CR178 Ducati Quick Shift sensor cable re-routing

Multistrada 950 S MY 2019

Multistrada 1260 S (all model versions) MY 2019

Technical Service Bulletin SRV-TSB-19-007

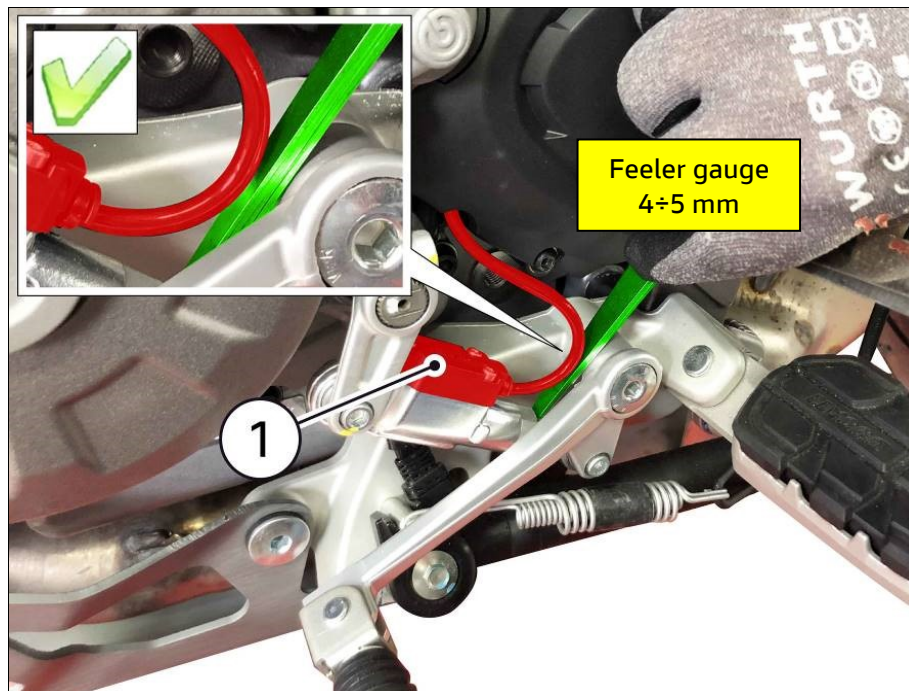
For the correct routing of the DQS sensor cable, you will have to check the distance between the **DQS sensor cable (1)** and the gearchange lever; carry out this check using a **4 - 5 mm** feeler gauge, as shown in the figure.

If the distance between the DQS sensor cable and the gearchange lever is between **4 - 5 mm**, cable routing is COMPLIANT and no corrective action is required.

NON-COMPLIANT DQS sensor cable routing

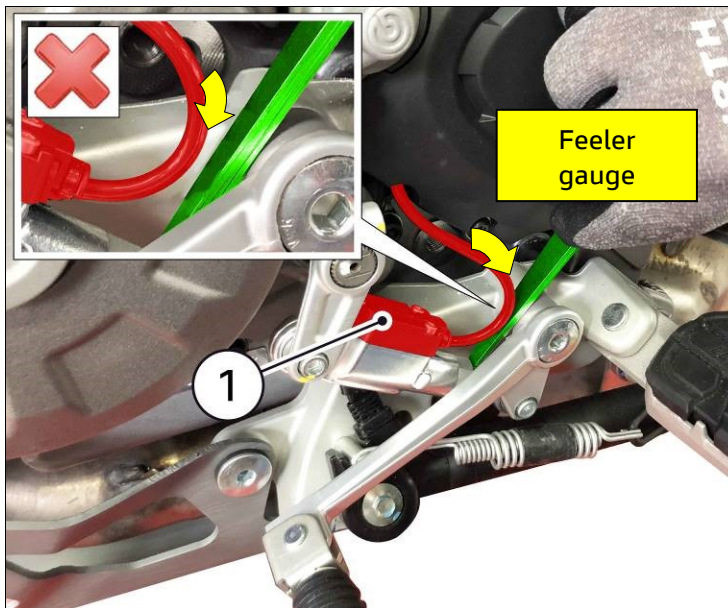
If the distance between the DQS sensor cable and the gearchange lever is more than the **4 - 5 mm** specified above, cable routing is NOT COMPLIANT.

Restore the distance between DQS sensor cable and gearchange lever by slightly pulling, without forcing, the cable downwards, as shown in the figure.
